# Rezoning Transportation Analysis

Petition Number: #2022-111

Date	Description
11-28-22	First Review (PDM)

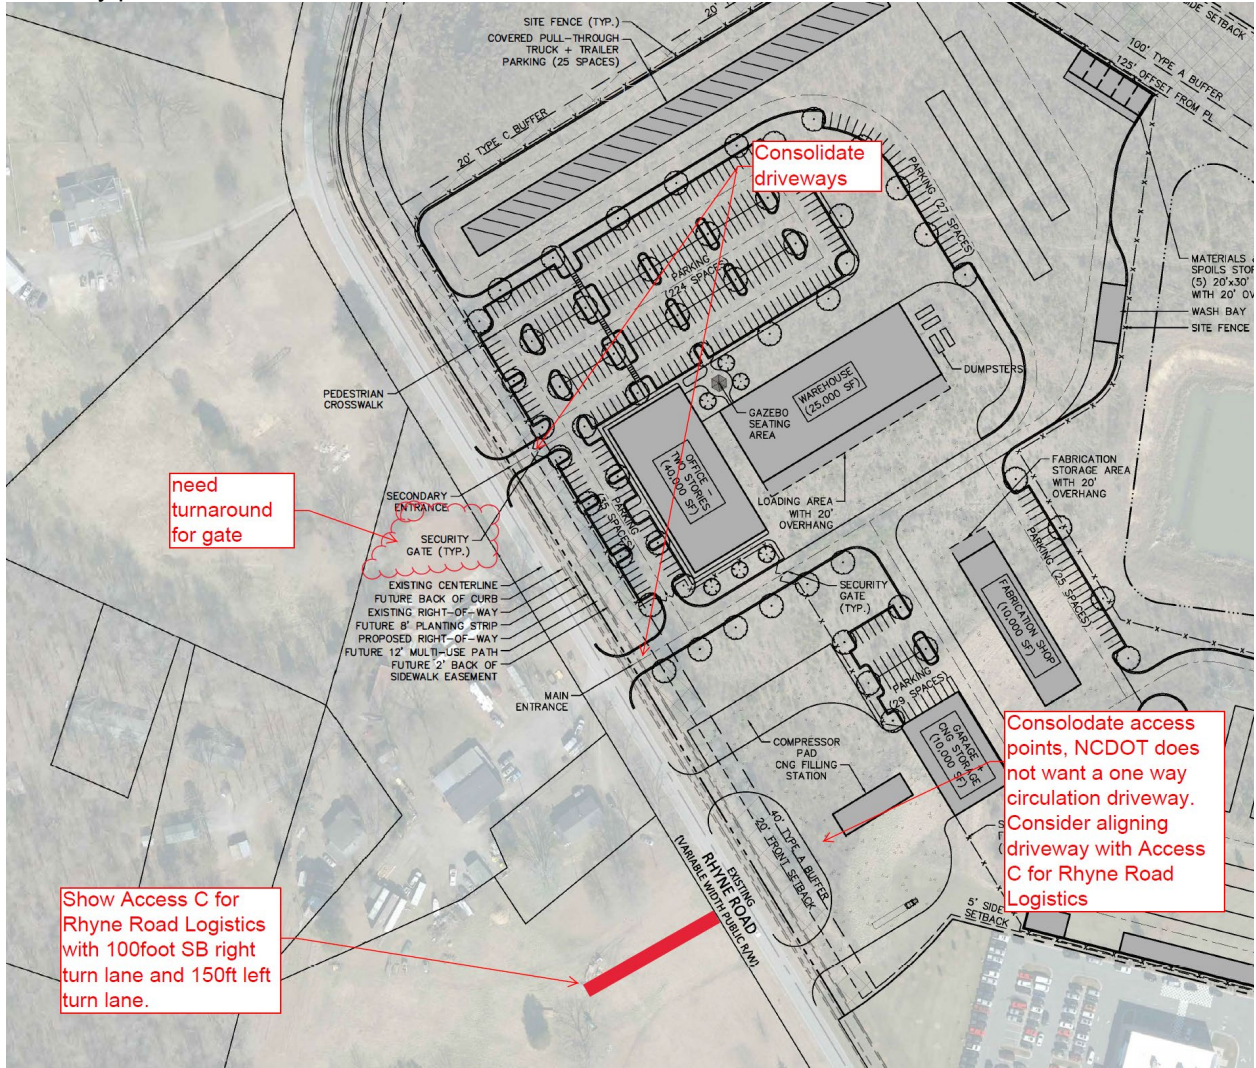
### 1. Curblines:

- a. **Rhyne Road:** Location of curb and gutter shall be placed 19-feet from the existing centerline to the back of curb.

Label and dimension the curb and gutter from the centerline.

Label and dimension the curb and gutter from the centerline for each road on the site plan.

3. Revise site plan and conditional note(s) to commit to dedicate 41-feet of right-of-way, along the site's frontage of Rhyne Road, from the road centerline. The site plan shall label and dimension the right-of-way from the road centerline.

4. Revise site plan and conditional note(s) to commit to construct an 8-foot planting strip, and 12-foot shared-use path along the site's frontage of Rhyne Road. The site plan shall label and dimension each item from the back of curb. Clearly show the shared-use path on the site plan.
